**RE: MC-14-16: Laurel TRI POINTE DeRose**

**Request 1. 2015-RDCS Narrative Circulation Efficiently Criteria B.2.c., Detached Sidewalks**

Figure 2 - 2015 RDCS Site Development Plan

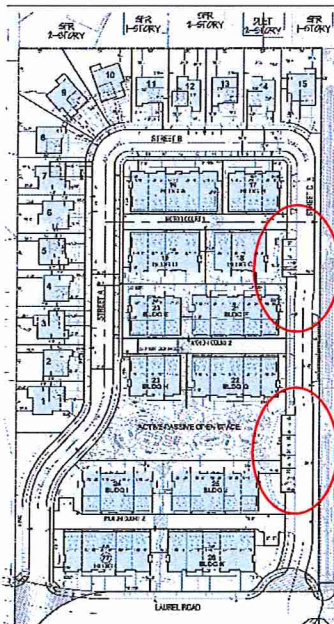
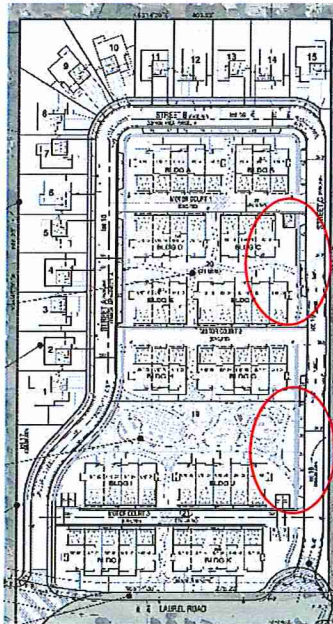
Note that the maximum point value for this criterion is two (2) points. Pursuant to last year's successful RDCS competition, in which this project was awarded five allocations, an application for Tentative Map and Precise Development Plan were submitted. Initial staff comments suggested that the perpendicular parking be replaced with parallel parking, which was a change reflected in this year's RDCS exhibits. (See Figure 1 for 2014 RDCS Site Development Plan, See Figure 2 for 2015 RDCS Site Development Plan). In making this change, the amount of curb-

adjacent sidewalk increased. Unfortunately, this changed negatively affected this year's RDCS scoring by one point. When considering the total length of sidewalk

adjacent to curb or planting strips (2,500 +/- linear feet), only 650 +/- linear feet is not adjacent to a 5-foot planting strip; in other words, sidewalks adjacent to a 5-foot planting strip represent three-quarters of the available length within the project. Consequently, we respectfully request that the point valuation reflect three-quarters of the available points in this criterion, for a total of 1.5 points. (See attached exhibit for sidewalk length calculation)

Applicant Answers		Staff Comments	
b.	Detached sidewalks are provided contiguous with the primary loop street.	2	The project provides detached sidewalks for a portion of the project. However, in several locations the sidewalk is curb adjacent. Therefore, the project is only entitled to a point since it does not fully meet the criteria for this category.
c.			1
